**RESOLUTION AUTHORIZING CHANGE ORDER NUMBER SIX (6) TO HERITAGE
CONSTRUCTORS, INC. - TEXAS WATER DEVELOPMENT BOARD PROJECT NUMBER:
21520: SEWER PLANT PROJECT (\$36,251.00)**

Change Order No. 6

Project: Waste Water Sewer Plant

RE: TexAmericas East Wastewater Treatment Plant Improvements
 Project Modifications

CONSTRUCTION PLANS
TEXAMERICAS CENTER
 EAST WASTEWATER TREATMENT PLANT 2011 IMPROVEMENTS
 CIVIL
 PROPOSED YARD PIPING SITE PLAN

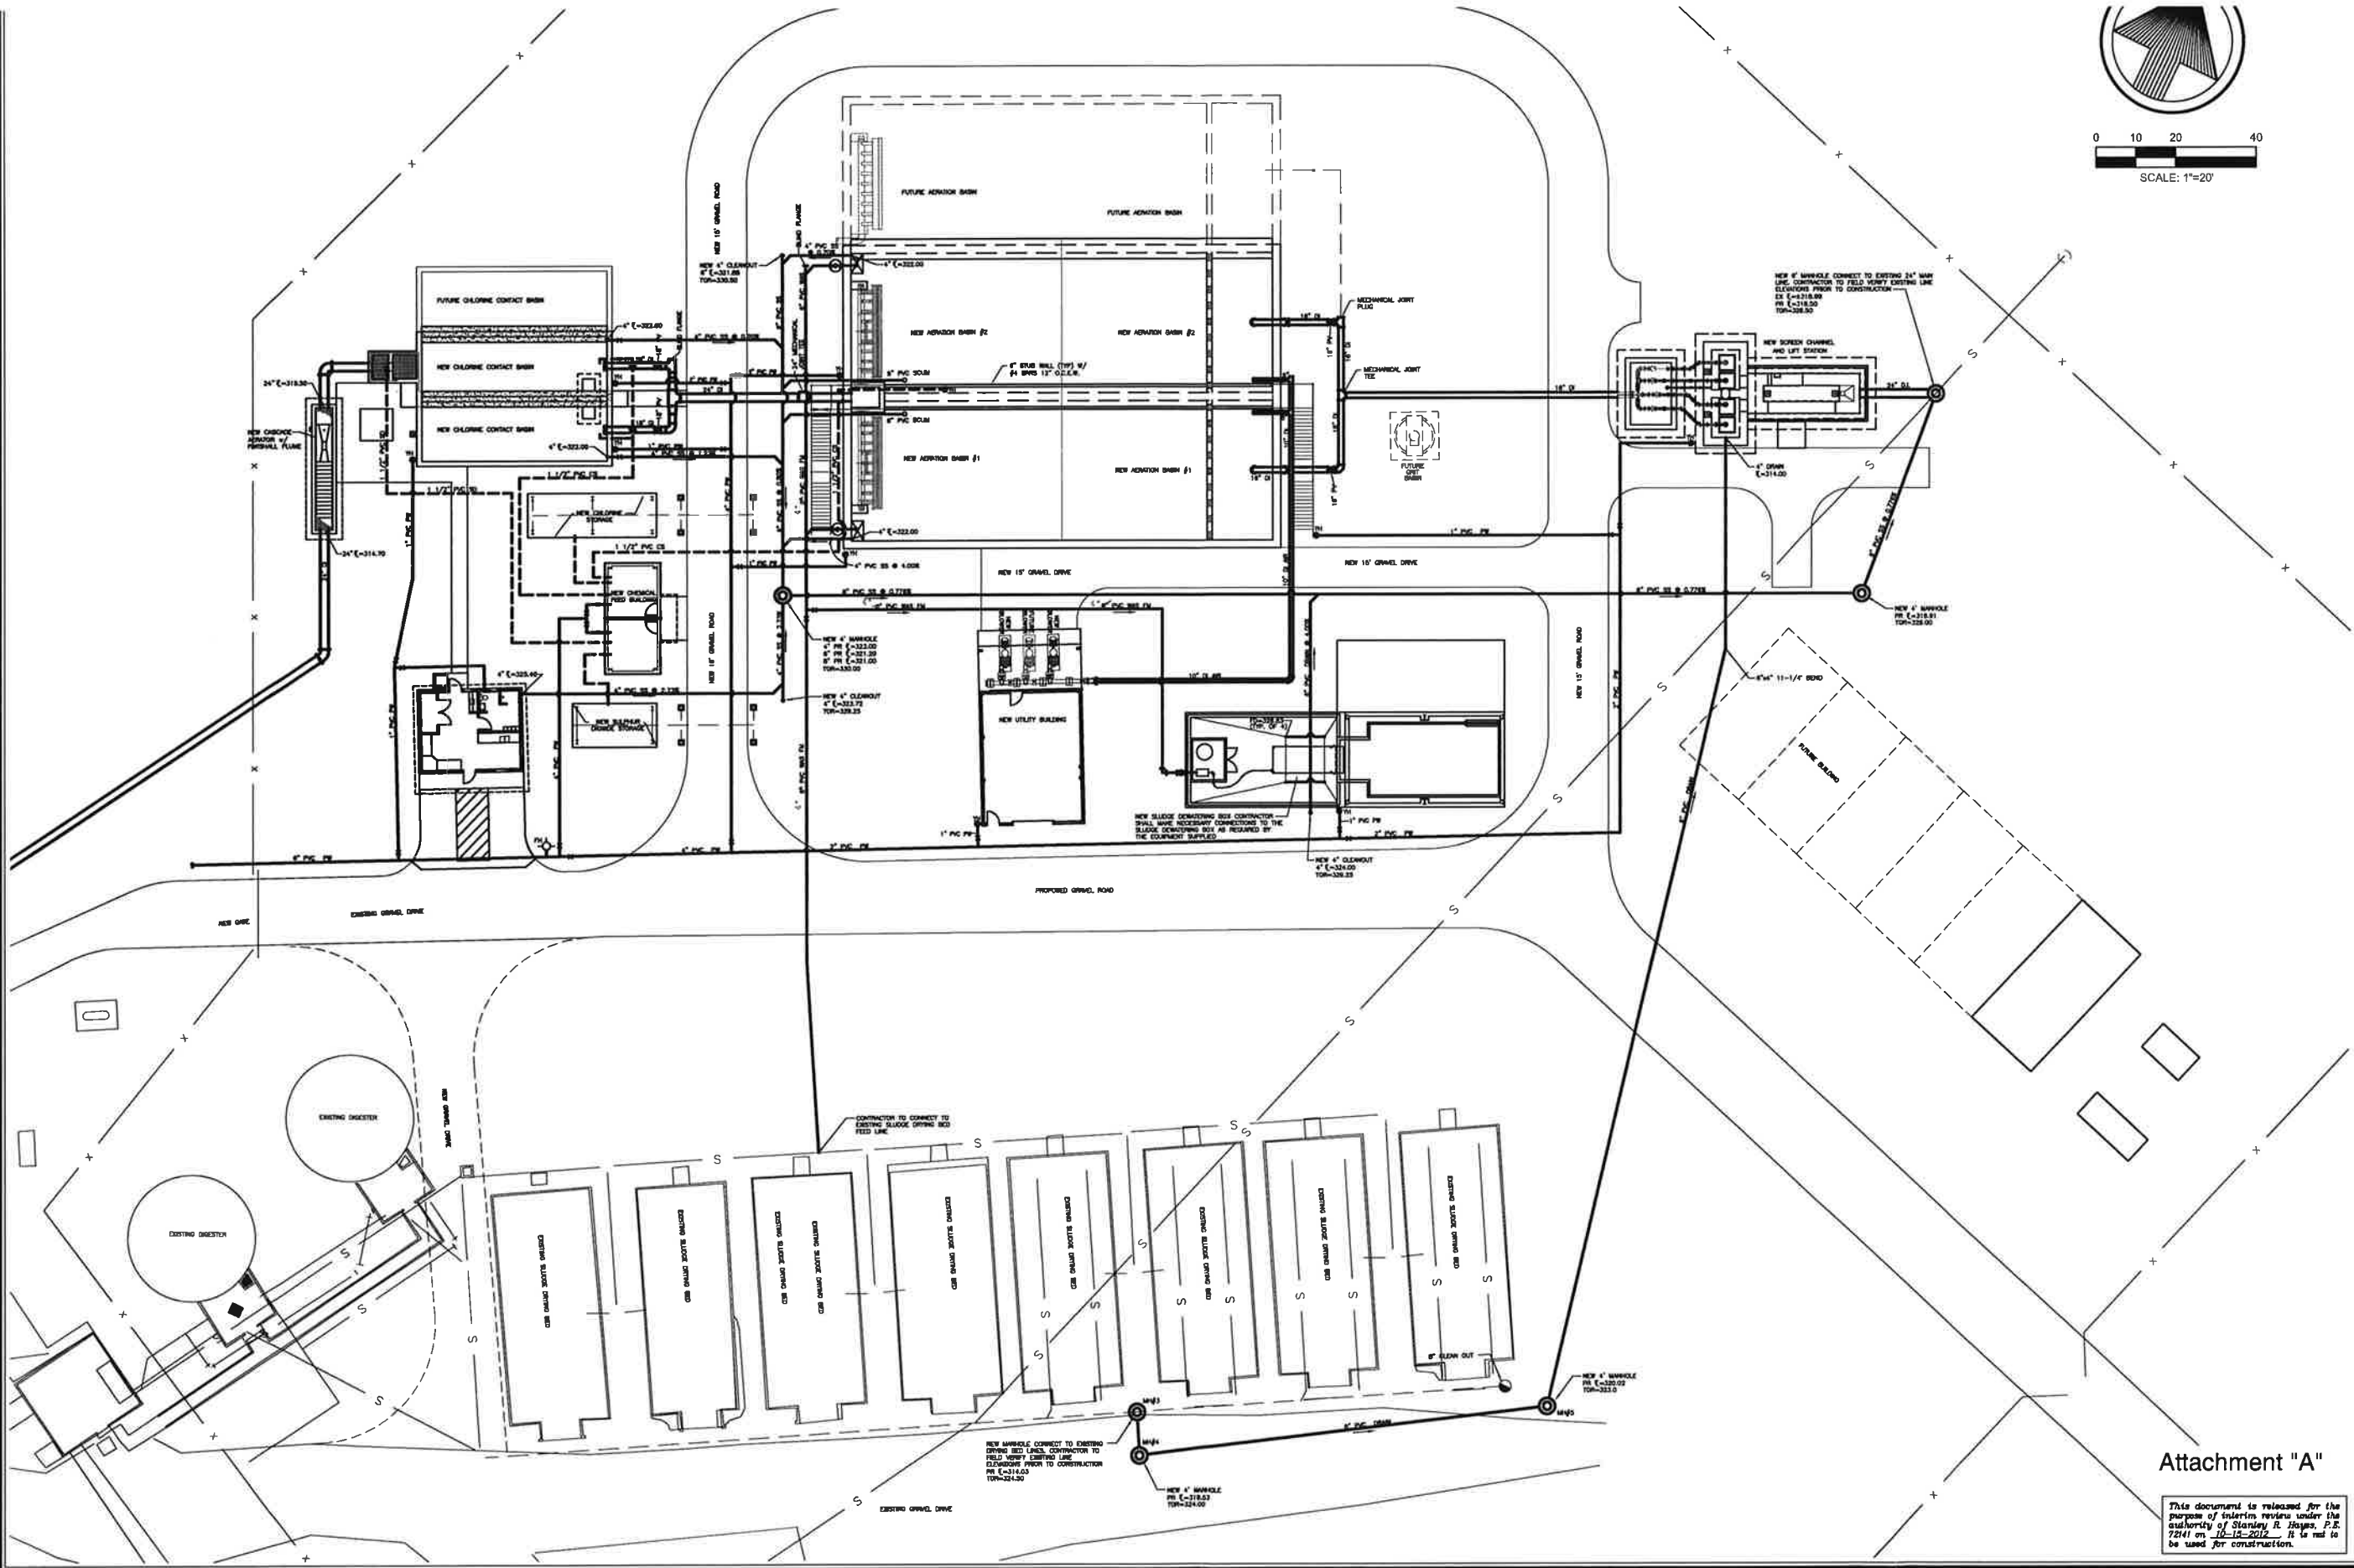
1. Modify project as shown on attachment "A".
2. Sludge Process System -
 - a. Delete Section 13205 Bolted SS Storage Tank, 11083 Positive Displacement Blowers and 11069 Progressive Cavity Sludge Pumps.

- e. See attachment "C".
3. Process Piping -
 - a. Modify piping as shown on attachment "A".
4. Chlorine Contact Chamber -
 - a. Delete stairs and platforms and perimeter handrail.

CONSTRUCTION PLANS
TEXAMERICAS CENTER
EAST WASTEWATER TREATMENT PLANT 2011 IMPROVEMENTS
CIVIL
PROPOSED CASCADE AERATOR w/ PARSHALL FLUME

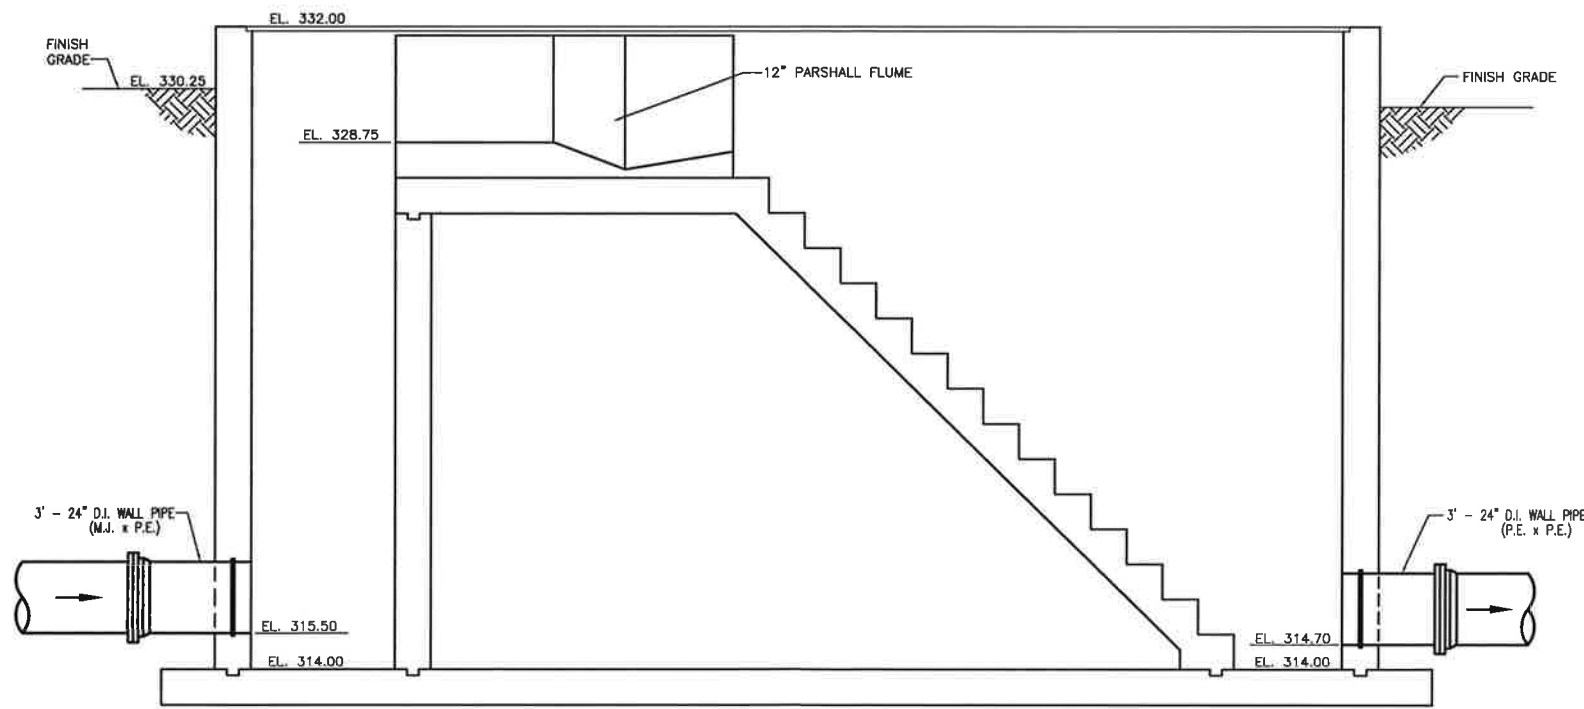
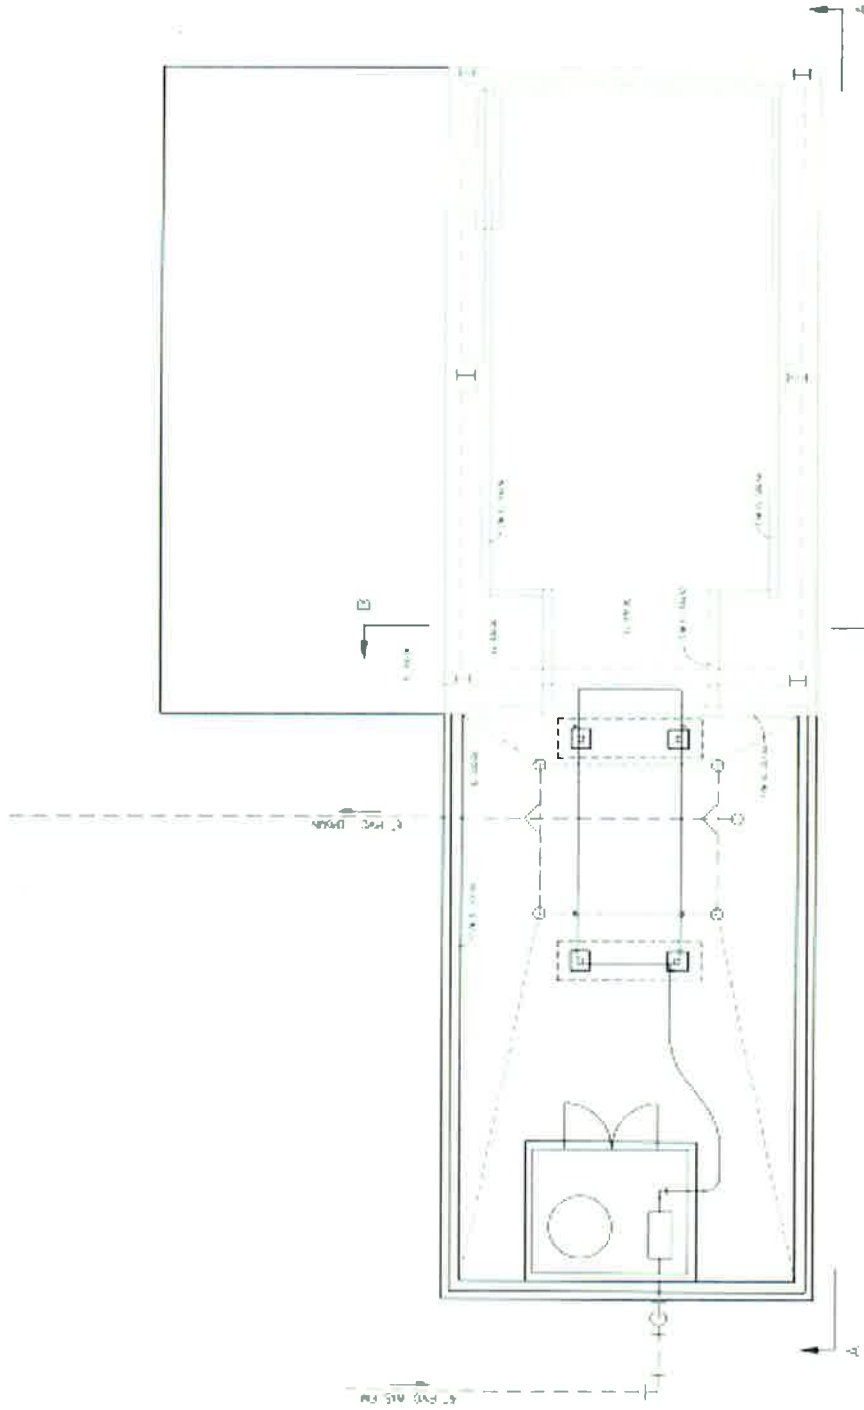
WHEREAS, Heritage Constructors, Inc. has requested a change order to made adjustments to site grading, yard piping, sludge dewatering and adds a cascade aerator (to address DO issues) with parshall flume. This scope of work is presented as change order number six (6) to the basic construction contract with a net increase of \$36,251.00, and is attached.
